Addendum No. 6, July 11th, 2025

Re: Johnson Hall Renovation – PKG 3
Johnson Hall Renovation & Foster Demolition
Tennessee Technological University
SBC Project No. 364/011-04-2022CM

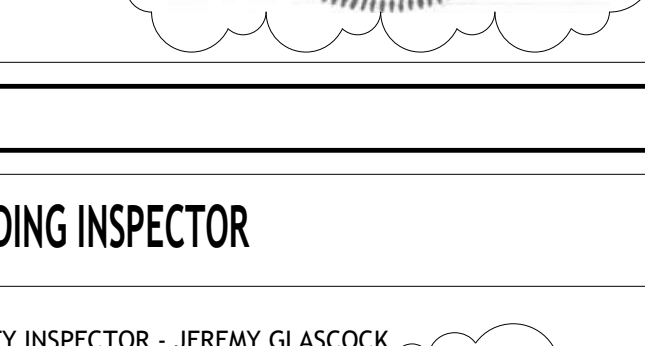
- 6) Refer to Cover 1, update index of drawings to include new revision dates of pages modified by this addendum.
- 7) Refer to sheet A4.12 detail 2. Change portico material to cement plaster on metal lath over 5/8" exterior sheathing board.

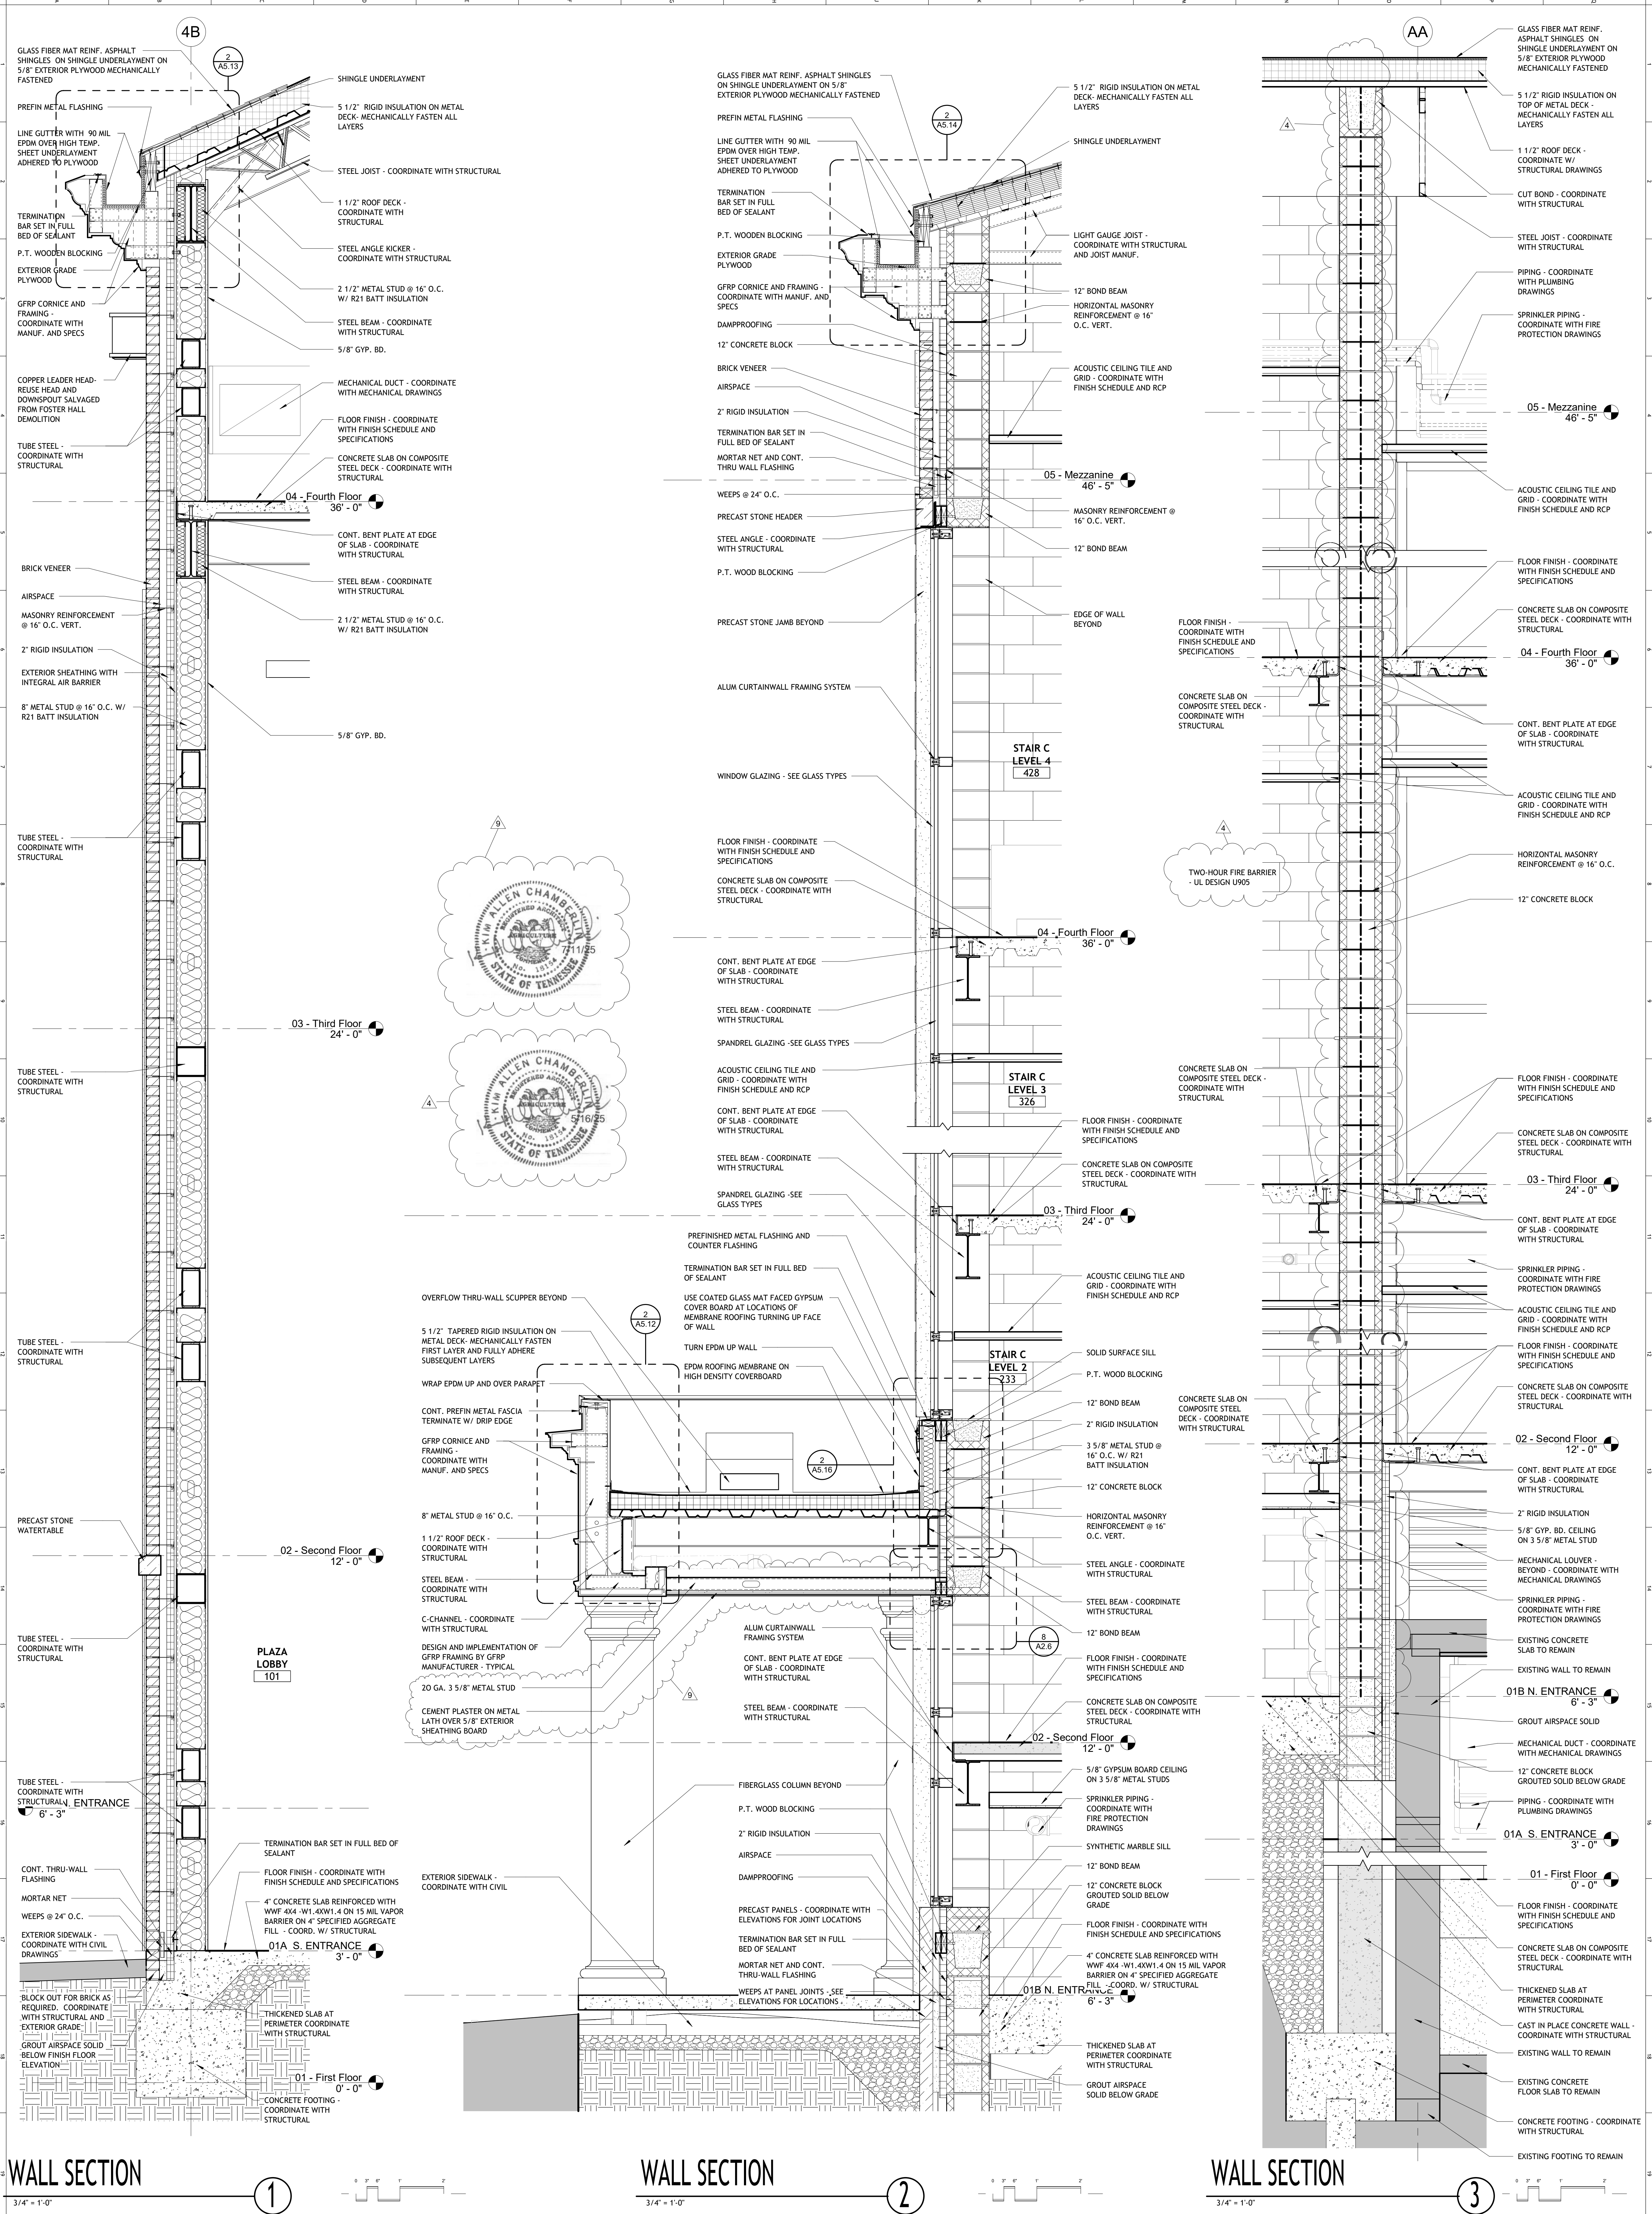
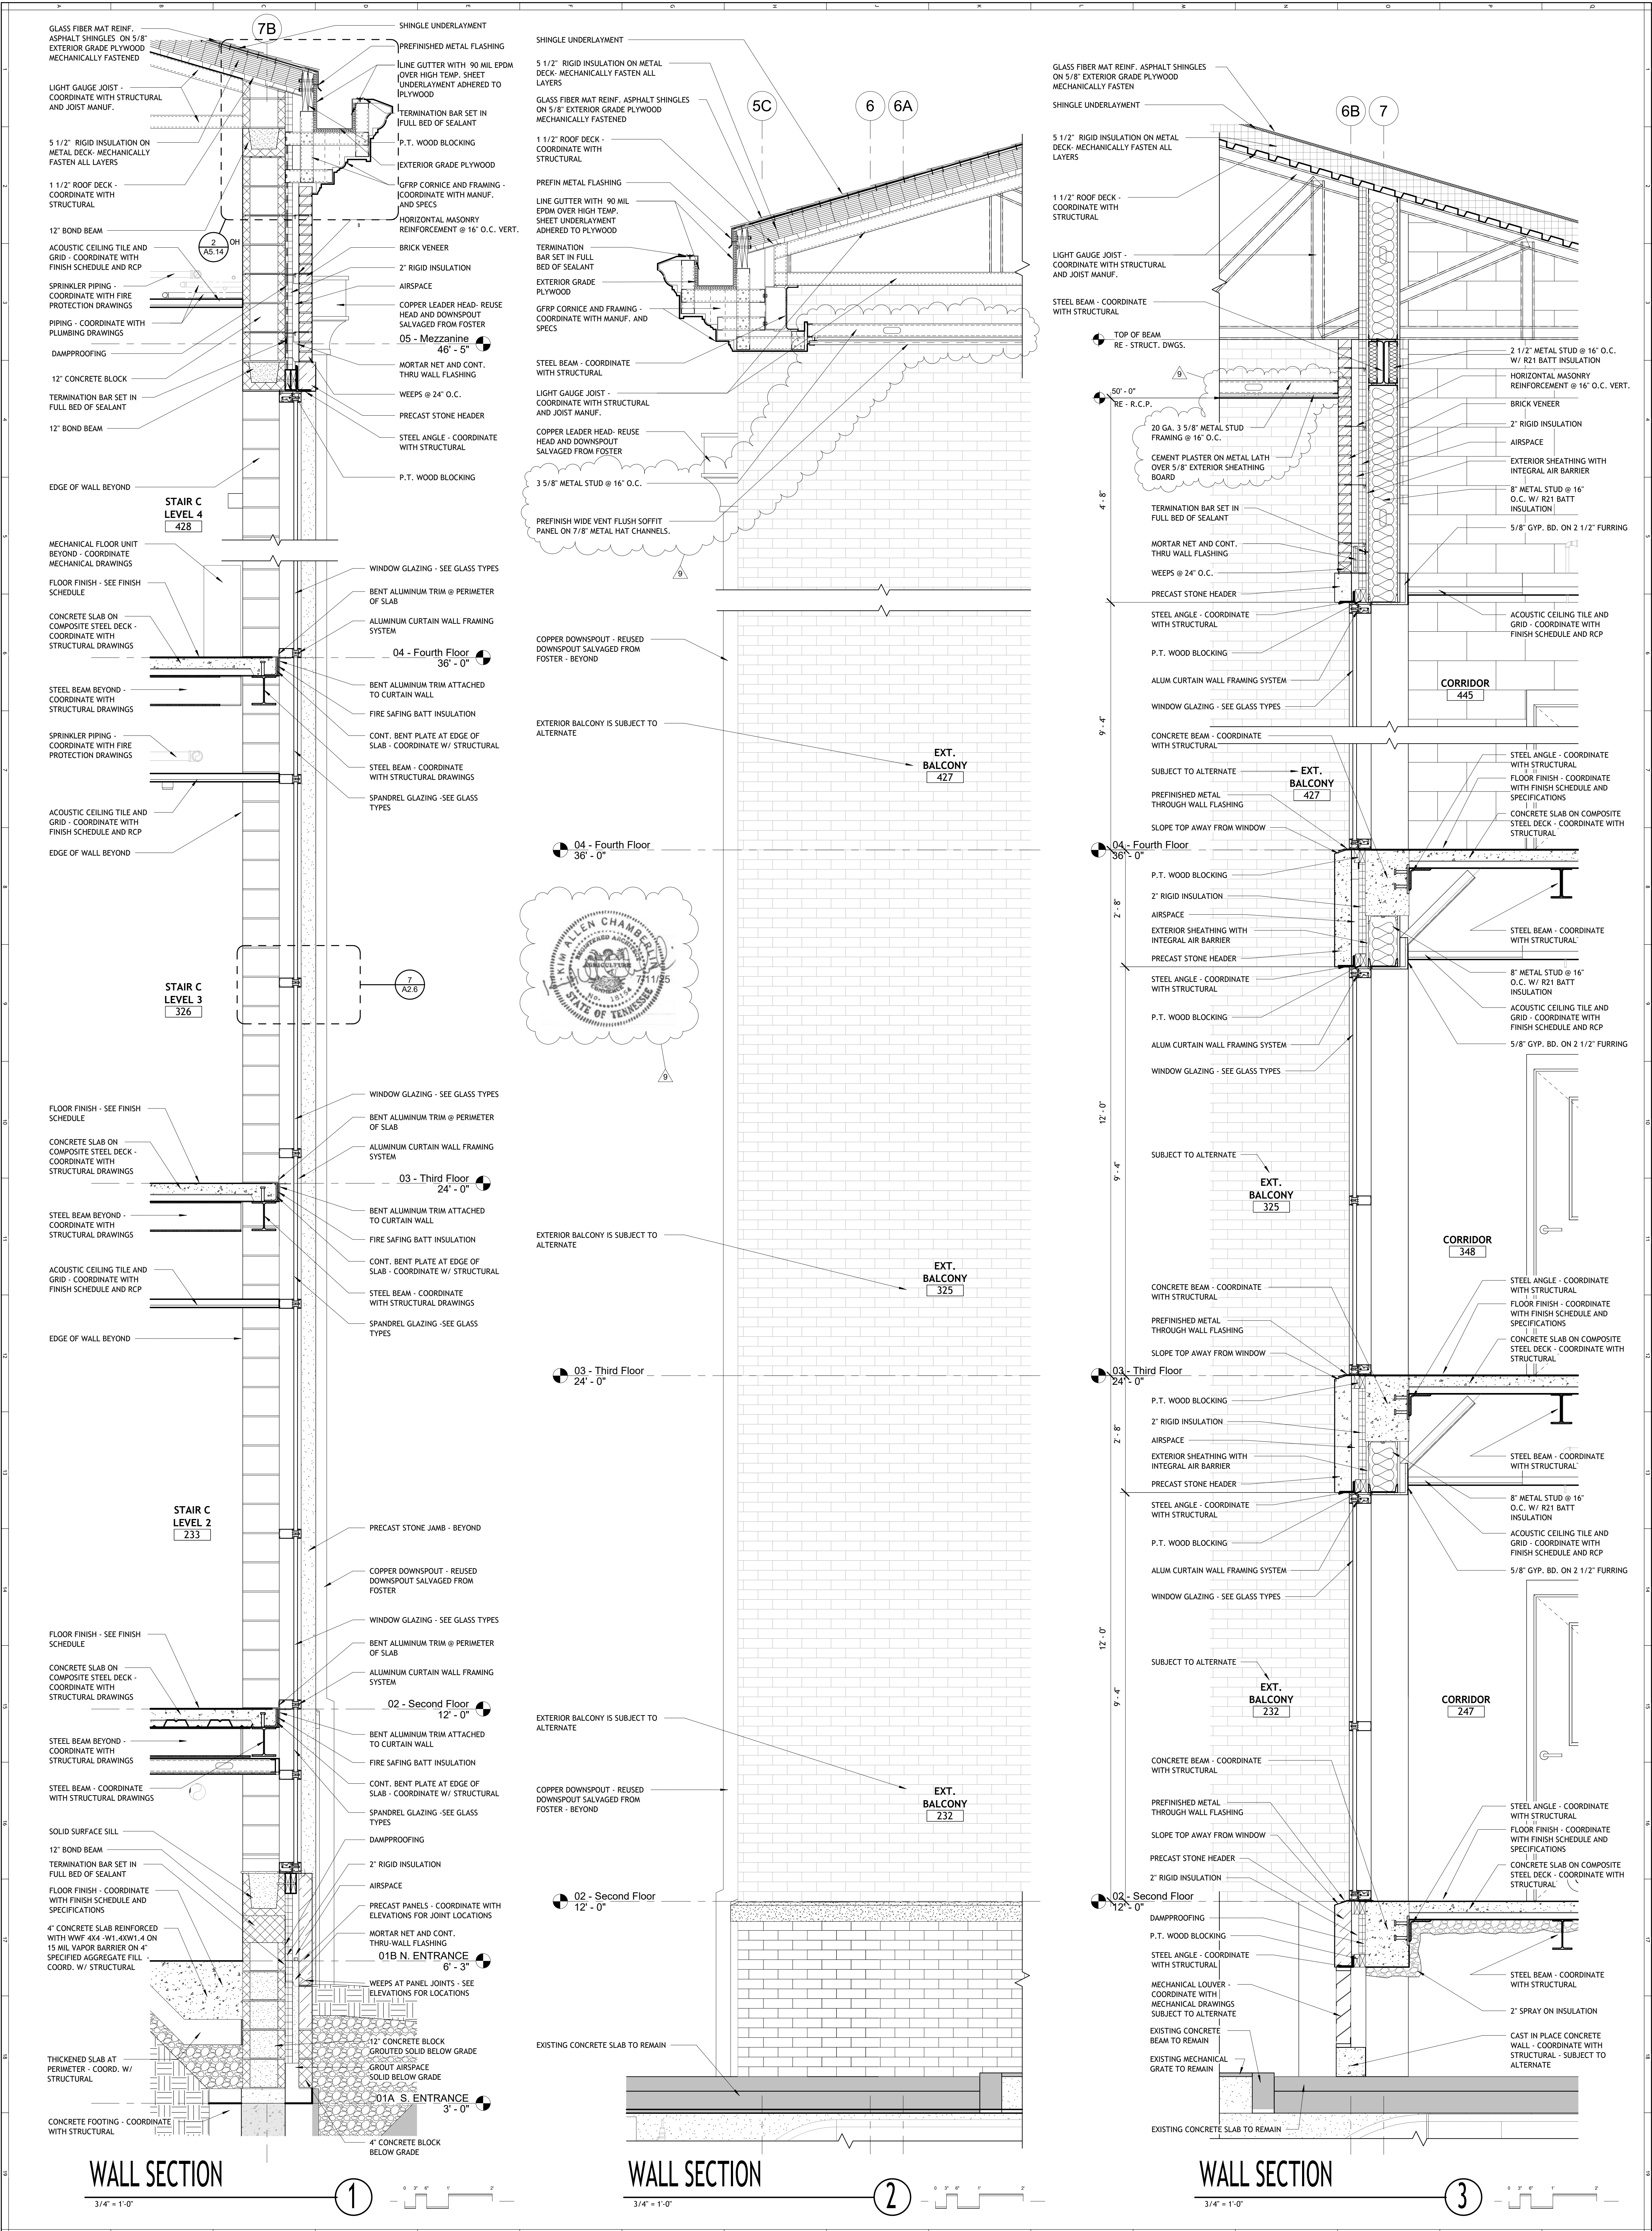
- 8) Refer to sheet A4.15 detail 2. Change portico material to cement plaster on metal lath over 5/8" exterior sheathing board.
- 9) Refer to sheet A4.18 details 2 and 3. Change portico material to cement plaster on metal lath over 5/8" exterior sheathing board.

- 10) Refer to sheet A4.20 details 1, 2 and 3. Change portico material to cement plaster on metal lath over 5/8" exterior sheathing board.
- 11) Refer to sheet A4.21 detail 2. Change portico material to cement plaster on metal lath over 5/8" exterior sheathing board.

- 12) Refer to sheet A4.22 details 1 and 2. Change portico material to cement plaster on metal lath over 5/8" exterior sheathing board.
- 13) Refer to Sheets A5.12, A5.13, A5.14, and A5.15. Add prefinished metal eave vent applied to bottom of GFRP panel to locations shown on revised details.
